Application Number 10/714,801
Amendment dated July 24, 2006
Reply to Office Action of May 22, 2006

Amendments to the Drawings:

FIG. 2

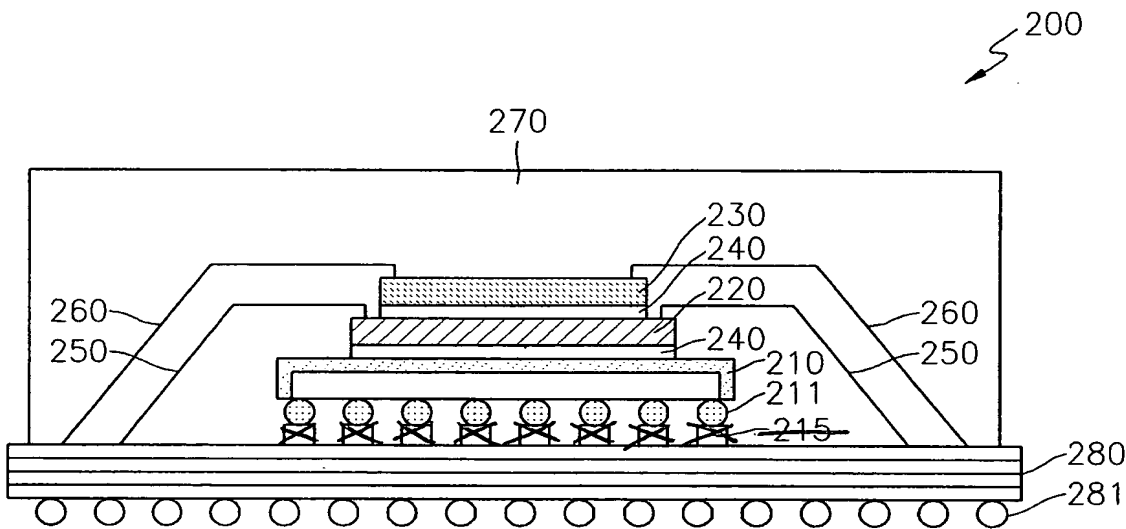
The attached sheets of drawings include changes to Figures 2, 4, 6, and 8. The sheets, which includes Figures 2, 4, 6, and 8, replace the drawings presented in the previous Amendment dated February 10, 2006. Specifically, Figure 2 is amended to remove solder bumps 215. In addition, Figure 4 is amended to remove solder bumps 415. In addition, Figure 6 is amended to remove solder bumps 615. In addition, Figure 8 is amended to remove solder bumps 815.
